**TOWN OF NEWBURGH
PLANNING BOARD
TECHNICAL REVIEW COMMENTS**

PROJECT NAME: MKJ PARK, LLC OFFICE & WAREHOUSE
PROJECT NO.: 22-32
PROJECT LOCATION: SECTION 34, BLOCK 2, LOT 29.1
REVIEW DATE: 1 MARCH 2024
MEETING DATE: 7 MARCH 2024
PROJECT REPRESENTATIVE: LANC & TULLY, PC /JOHN QUEENAN, P.E.

P.O. Box 687, Rt. 207 Goshen, N.Y. 10924 (845) 294-3700
DATE: OCTOBER 18, 2023 REVISION: FEBRUARY 26, 2024		
SITE PLAN PREPARED FOR		
MKJ PARK, LLC		
TOWN OF NEWBURGH ORANGE COUNTY, NEW YORK		
Drawn By: JW Checked By: Scale: 1" = 50' Tax Map No.: 34 - 2 - 29.1	Drawing No.: 3 OF 9 A- 21 - 0047 - 01

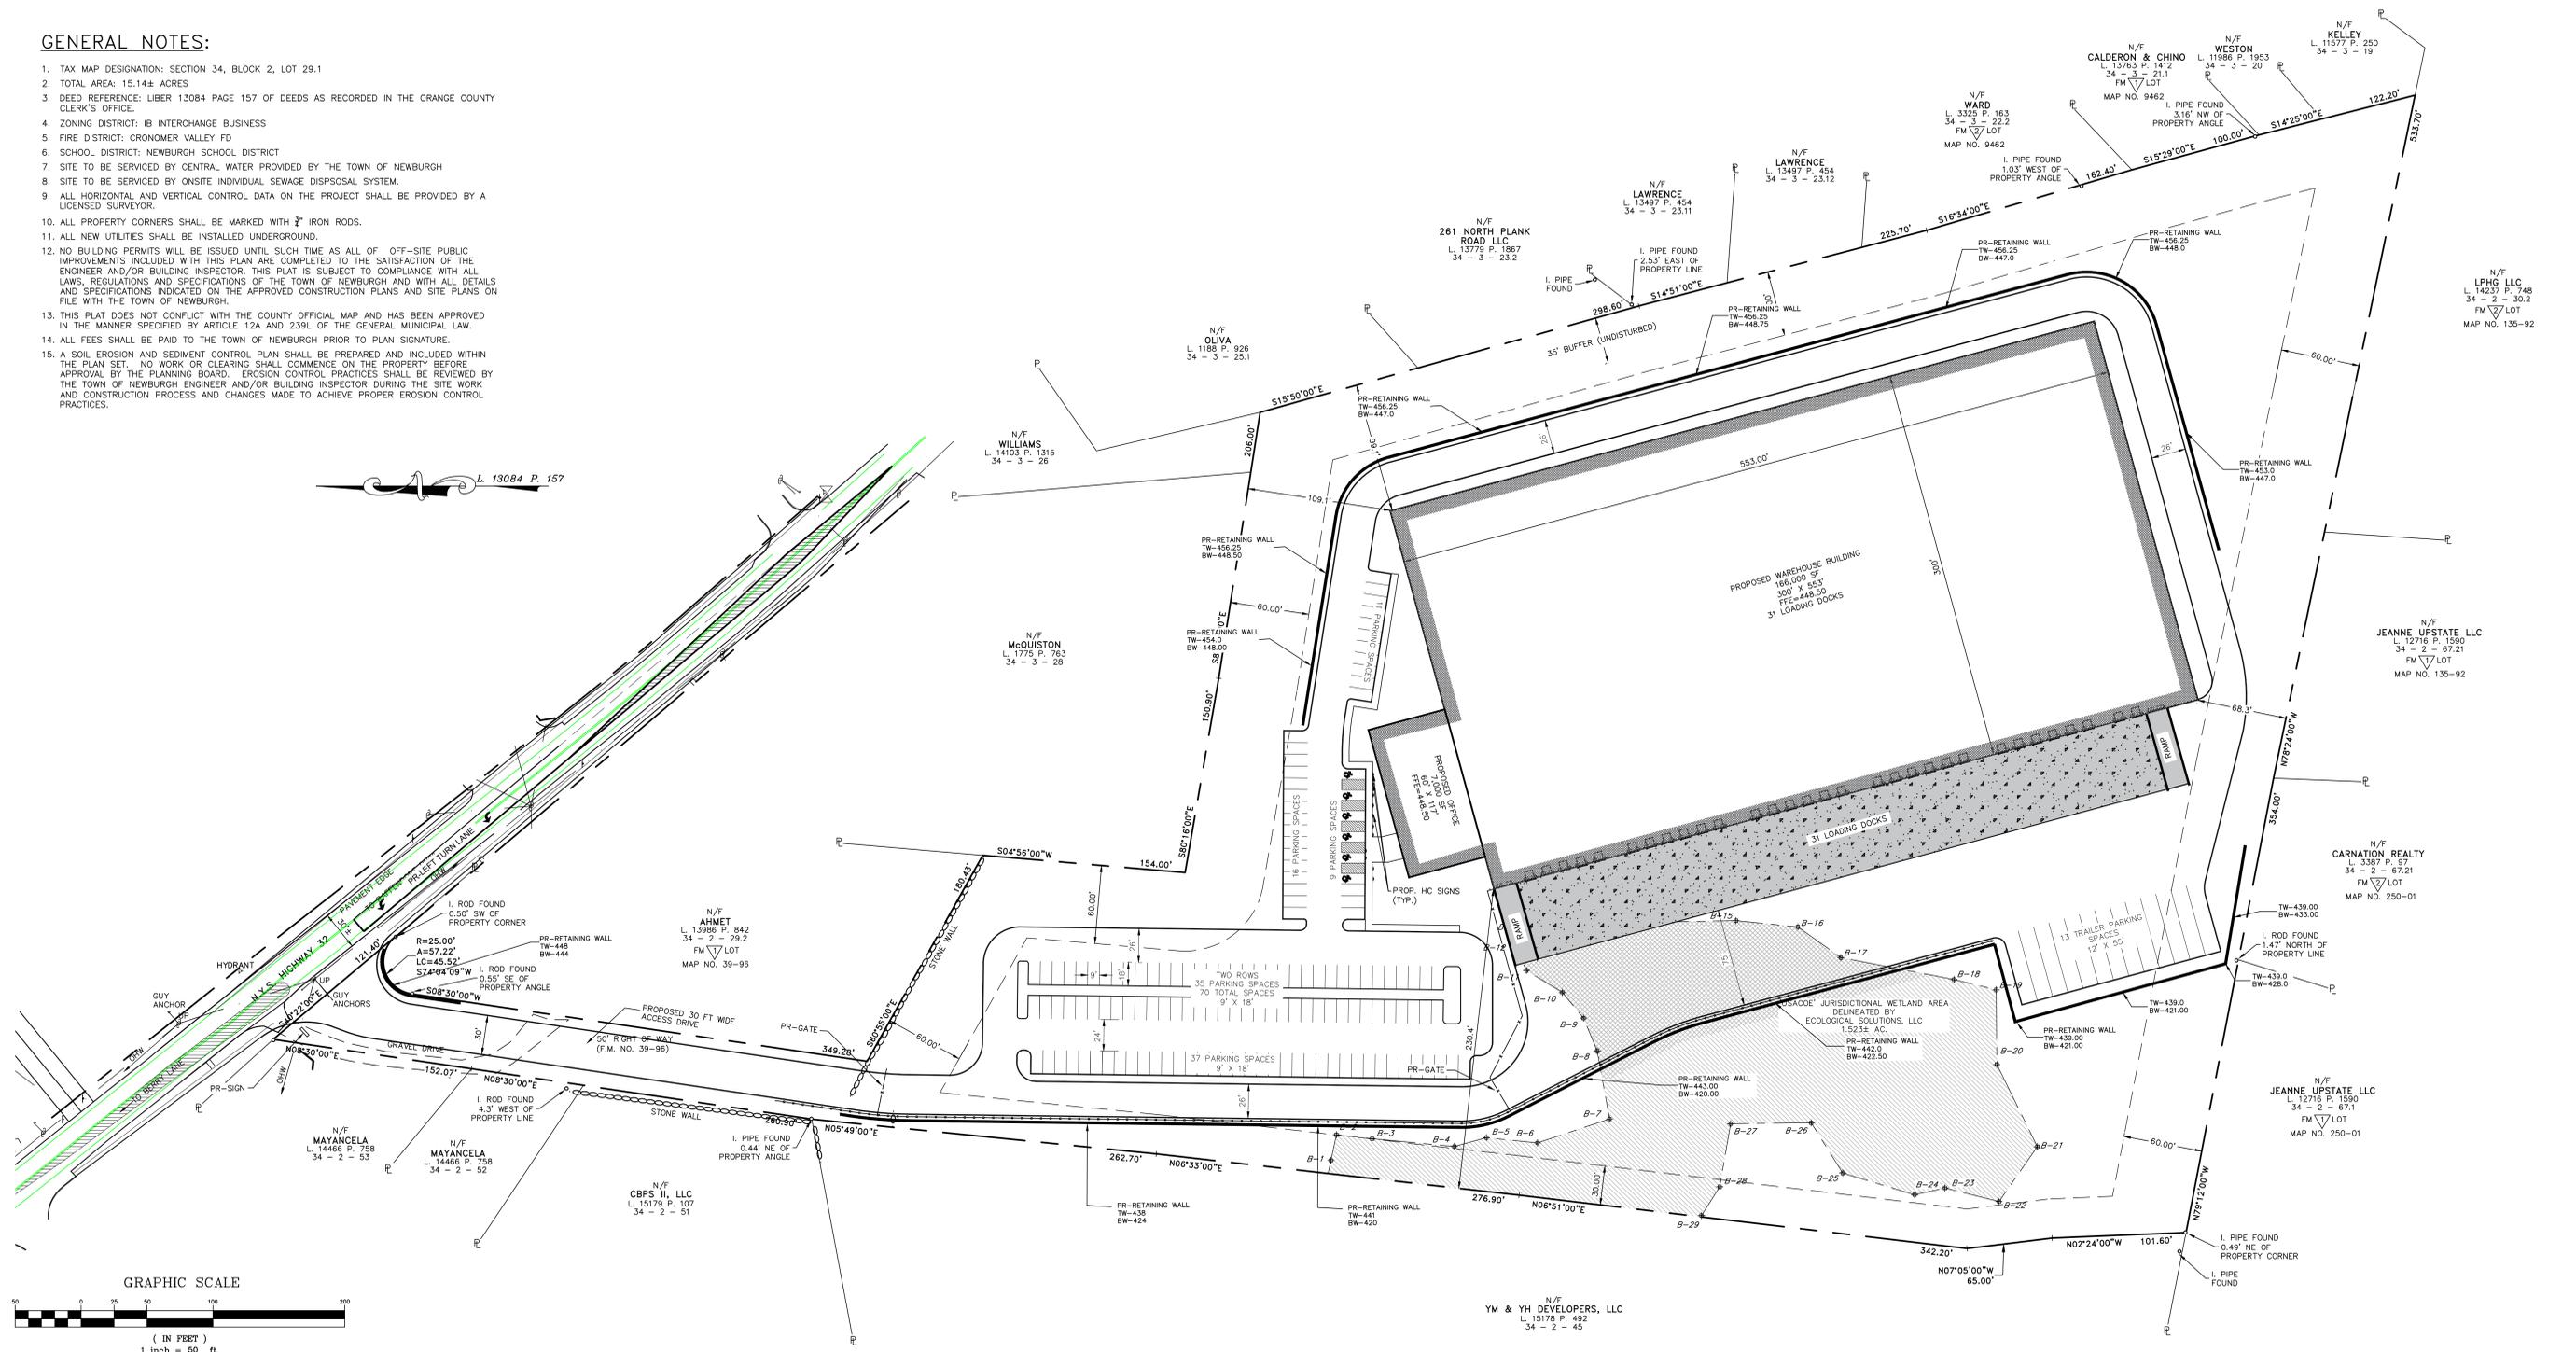
1. The project must still address the single access point for the structure which exceeds the size for the NYS Building Code of having a single access point.

2. The project has increased the undisturbed buffer between the adjoining residential properties to the east of the site to 35 feet. It is noted that those properties are located in the IB Zoning District which does not require compliance with the Town's extensive buffer requirements typically required for commercial properties abutting residential properties in a residential zone.
